REMARKS/ARGUMENTS

Appl. No. 10/037,278
Amdt. dated June 16, 2005
Reply to Office Action of March 16, 2005

FIG. 1B

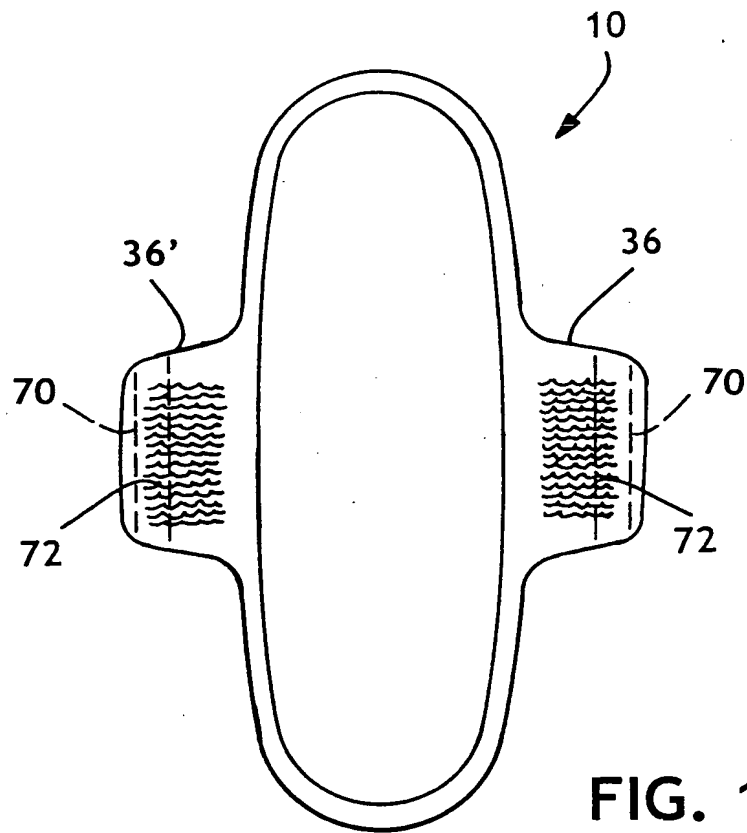
The Examiner also states in the Office Action that the submitted drawings did not include corrections of all the objections to the drawings, in particular to Figures 1B and 1C. Applicants are submitting herewith a new sheet of drawings including Figures 1B and 1C. Applicants' undersigned representative, based on Applicants file, was under the impression that formal drawings for Figures 1B and 1C were previously filed. However, upon reviewing the Private Pair and the file image, it was discovered that formal drawings for Figures 1B and 1C are not part of the Patent Office's electronic file.

The attached sheet of drawings includes changes to Fig. 1B and 1C. This sheet, which includes Fig. 1B and 1C, replaces the original sheets including Fig. 1B and 1C.
